JORDAN VALLEY WATER TREATMENT PLANT
FILTER AND CHEMICAL FEED UPGRADES

JVWCD PROJECT #4289

ADDENDUM NO. 2
TO THE
CONTRACT DOCUMENTS

APRIL 2025

JORDAN VALLEY WATER TREATMENT PLANT
FILTER AND CHEMICAL FEED UPGRADES
DEMOLITION
ELECTRICAL PLAN 3

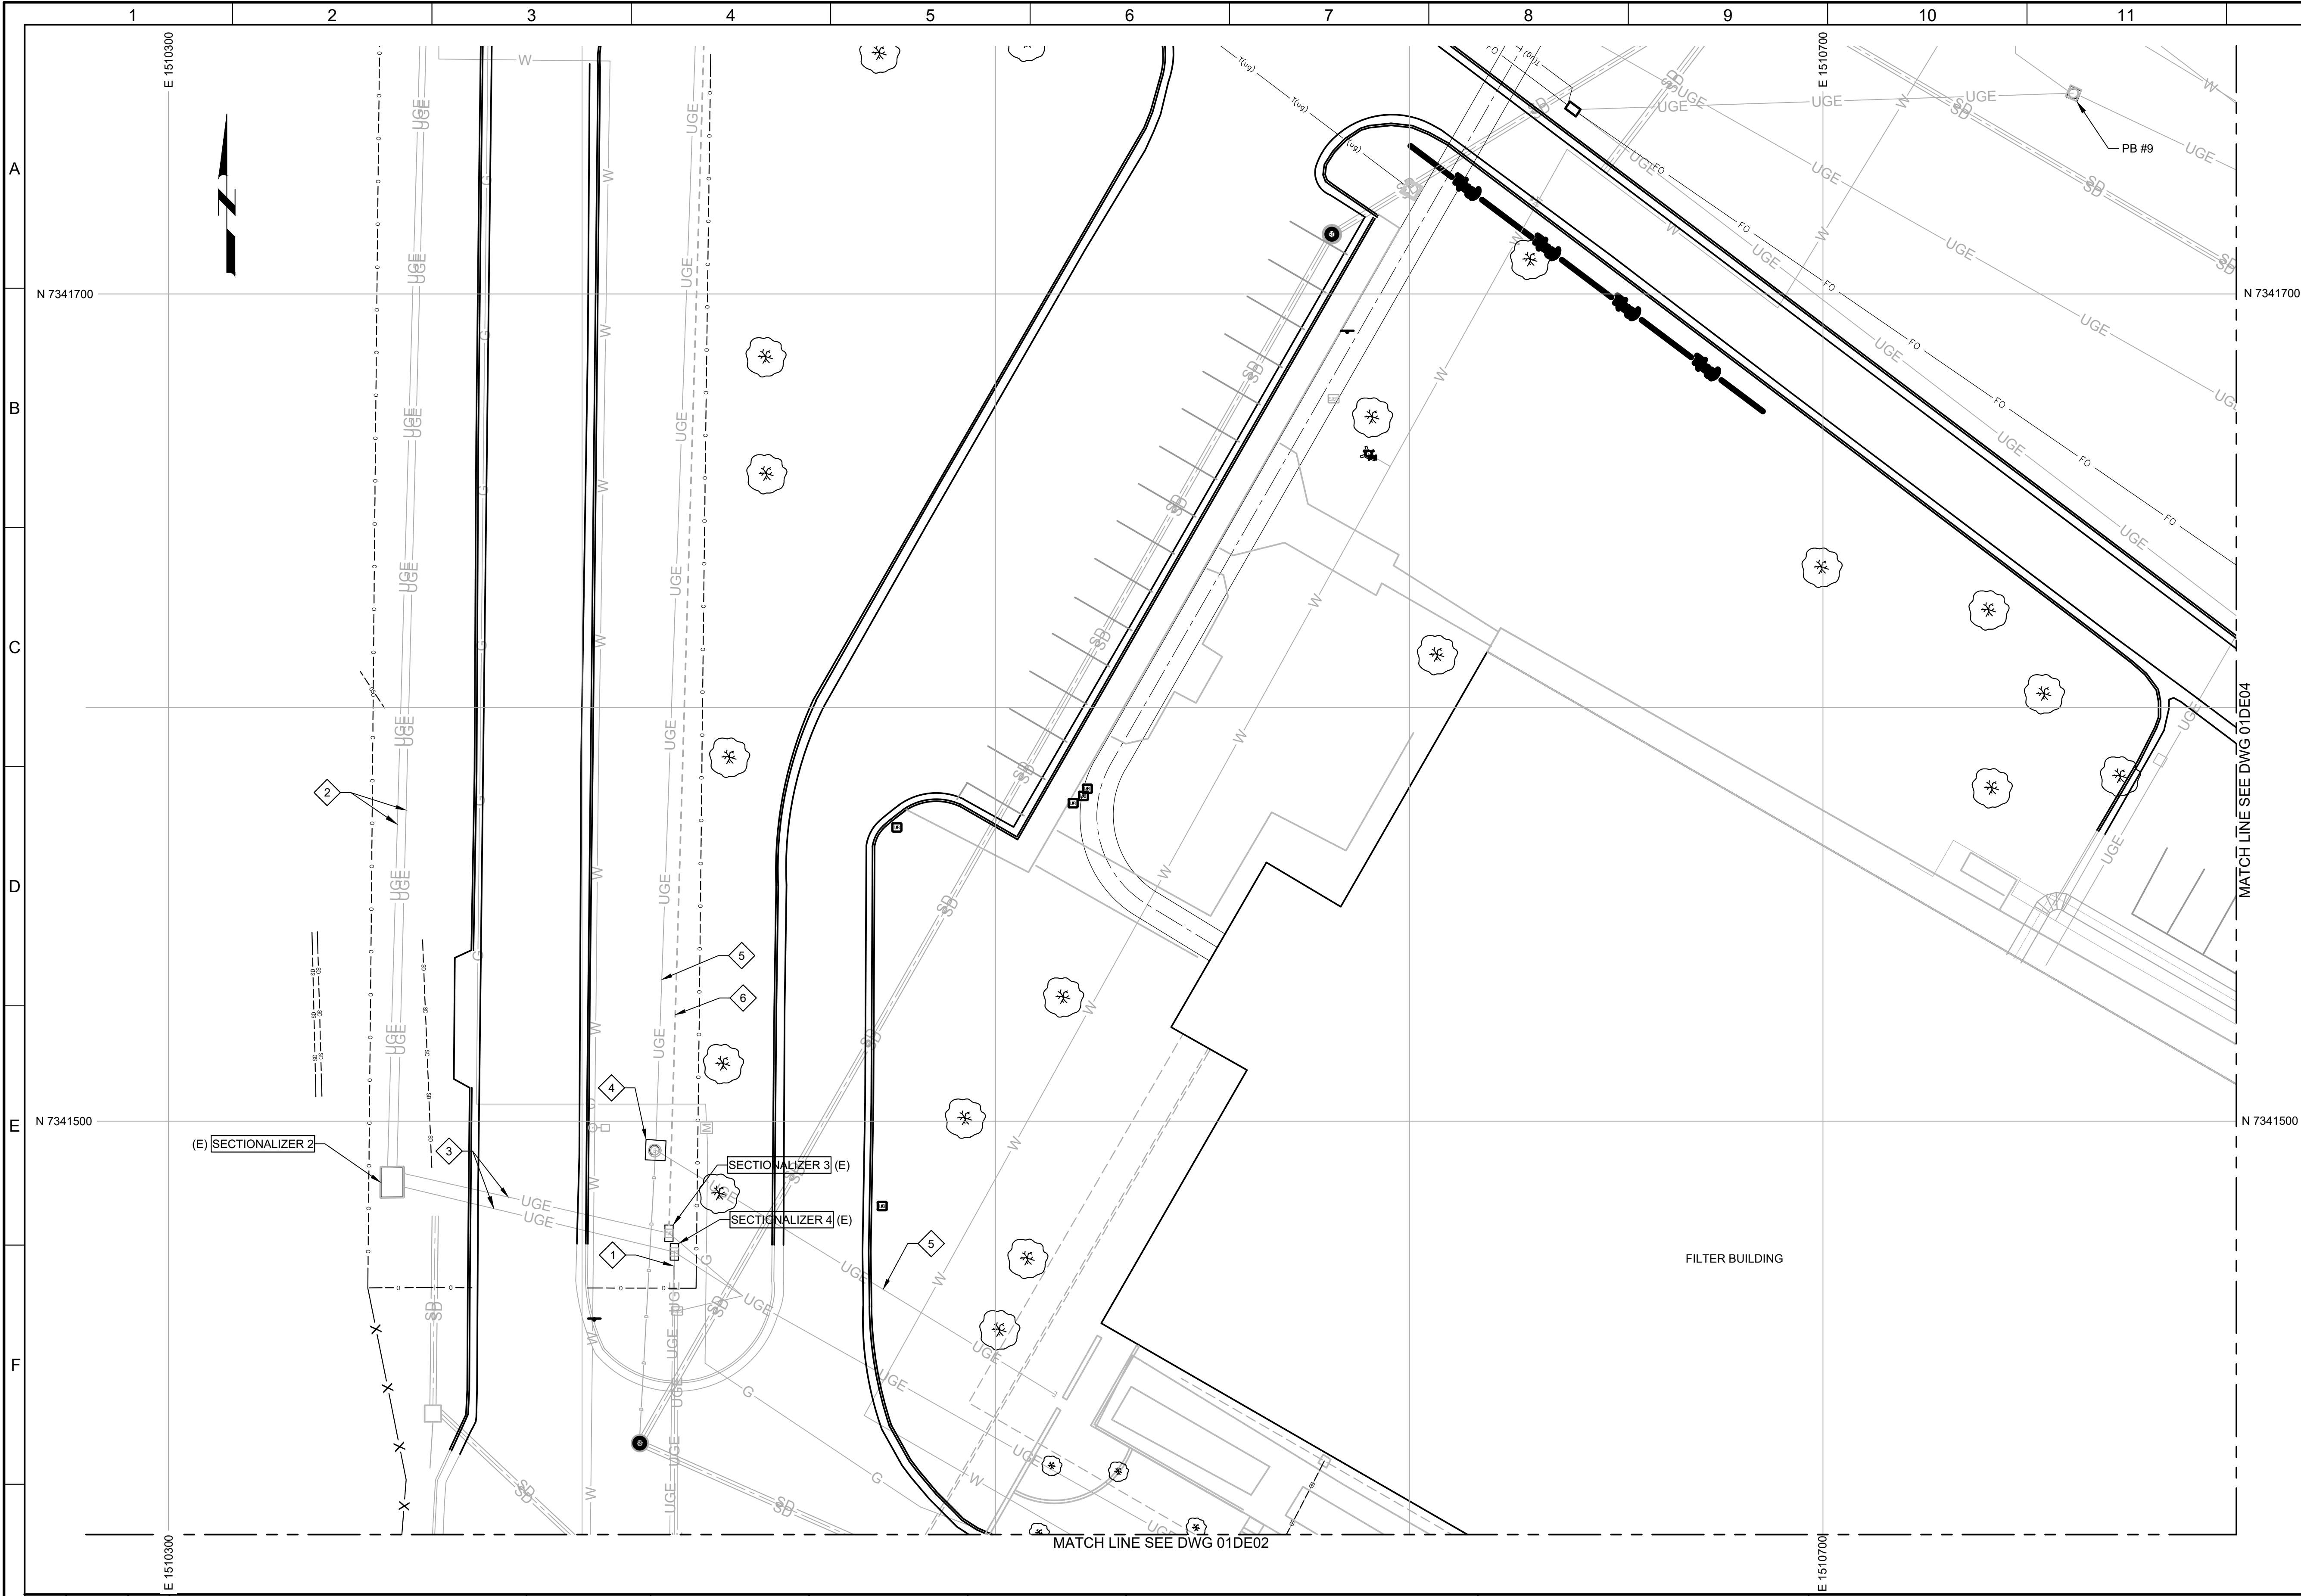
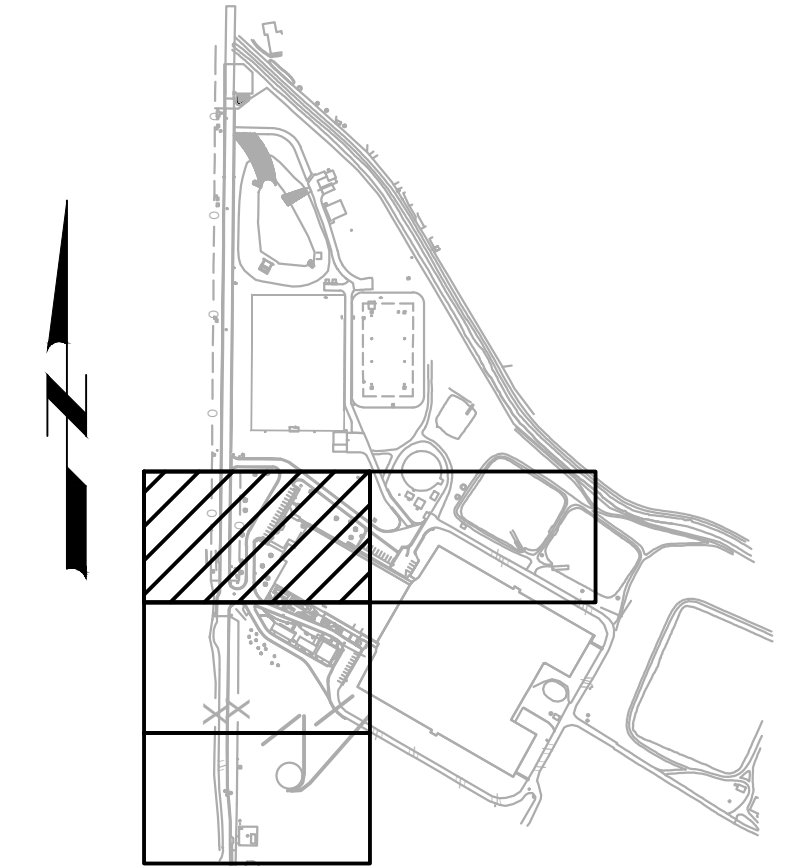
1. DEMOLISH 12.47 KV CONDUITS AND CONDUCTORS BETWEEN SECTIONALIZER 4 AND XFMR. CELL. DUCT BANK (NOT CONCRETE ENCASED) CONTAINS TWO 4-INCH CONDUITS AND ONE 2-INCH CONDUIT.
2. THREE EXISTING 5-INCH CONDUITS, 1 EMPTY SPARE, 2 IN USE. **PROTECT IN PLACE.**
3. TWO 4-INCH CONDUITS. **PROTECT IN PLACE.**
4. EMPTY PULLBOX. **PROTECT IN PLACE.**
5. EMPTY SPARE CONDUIT. **PROTECT IN PLACE.**
6. EXISTING UGE TO XFMR-APF FROM SECTIONALIZER 4, CABLED BELOW SECTIONALIZER 3. **PROTECT IN PLACE.**
